**ADMINISTRATIVE NON-STANDARD LOCATION**

**Administrative Order NSL - 9213**

**Hilcorp Energy Company [OGRID 372171]  
San Juan 32 08 701 Federal Com Well No. 603H  
API No. 30-045-38389**

Re: **Unorthodox Well Location Application**

Application for Unorthodox Well Location:  
San Juan 32 8 701 Federal Com 603H (API: 30-045-38389) Mancos Formation

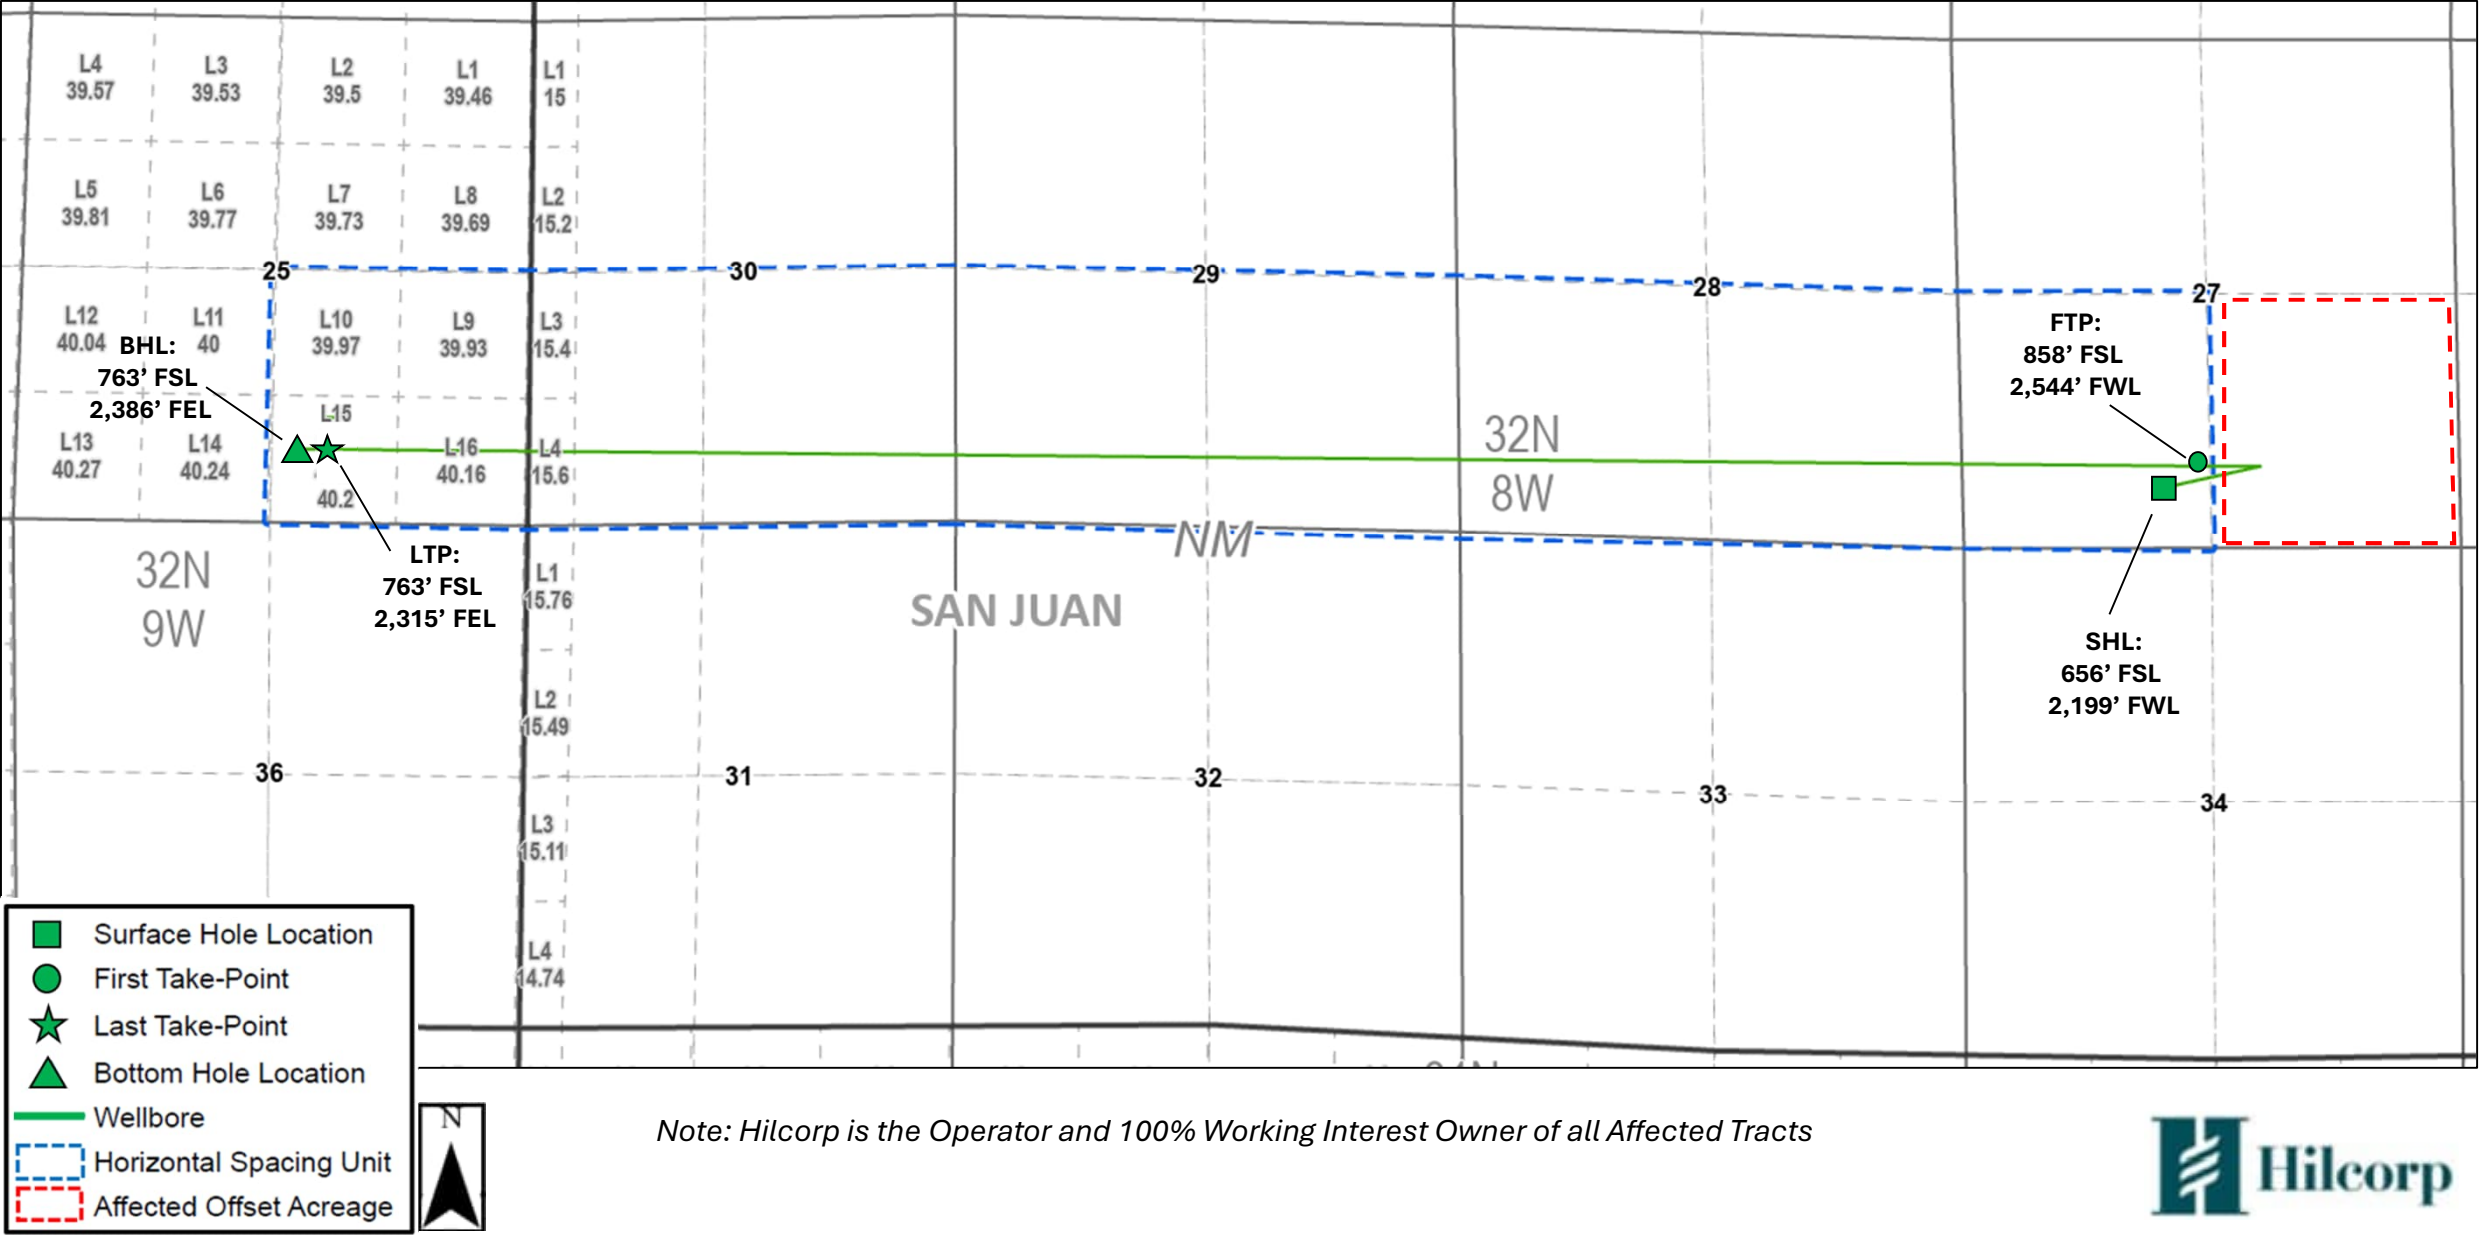
The LTP of the Well is compliant with the 330-foot setback requirement at approximately 354 feet from the western boundary of the HSU. The completed interval of the Well's lateral is also compliant with the 660-foot setback requirement from the northern and southern boundary of the HSU.

*However*, the FTP, situated approximately 45 feet from the eastern boundary of the HSU **is not compliant** and encroaches upon the following quarter section:

- Encroachment by FTP: SE/4 of Section 27, T32N-R8W

Per Subsection B of 19.15.15.13 NMAC, **Division approves this unorthodox location.**
